Remarks

Amendments to the Drawings

Annotated Sheet Showing Changes

Fig. 5.

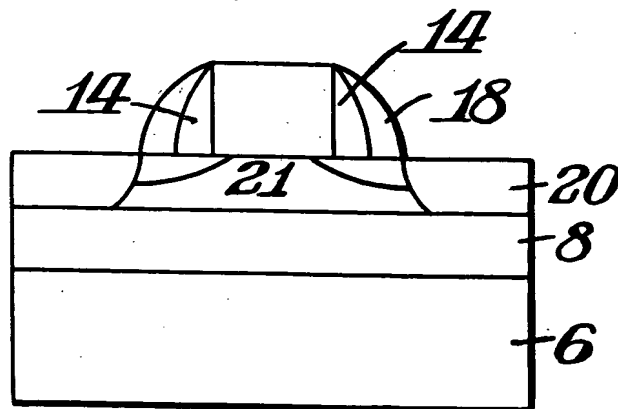
The attached annotated sheets, attached as Exhibit A herewith, include the original drawing sheet containing Figs. 2-7, with changes to these drawings shown in red ink. The changes are extending the lead line for reference numeral "14" in Fig. 5, and adding reference numeral "17" to Figs. 6 and 7. A replacement drawing sheet that includes Figs. 2-7 is also attached as Exhibit A. This attached replacement sheet replaces the original drawing sheet including Figs. 2-7.
